Access Compliance Report Public Rights-of-Way (Curb Ramps)

Main Street: SIENNA_PKWY		Cross Street: WINDMILL_AVE		Location:	S
ADA ID: RPRK211109120000	Ramp Type:Type 1 - Perpendicular	Initial Pass/Fail: Fail	Overall Compliance: No	Severity Score:	32
Codes/Mitigation Info/Possible Solution			Field Measurements/Component Compliance

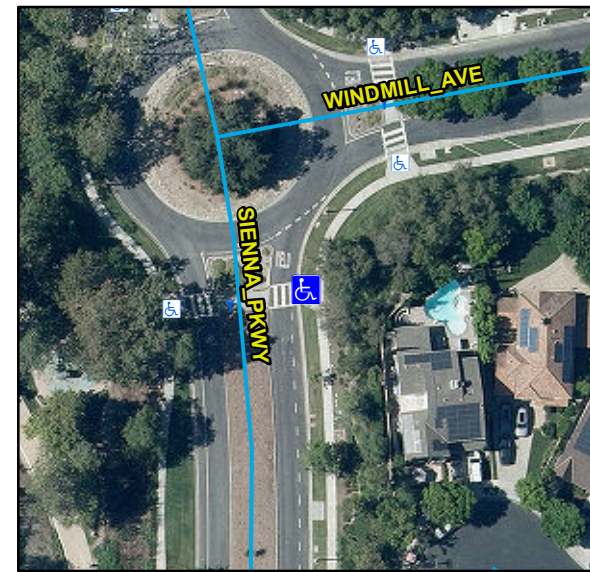
R304.2.2, R204.3, R304.5.3, STD 1115

Remove & Replace Entire Ramp.
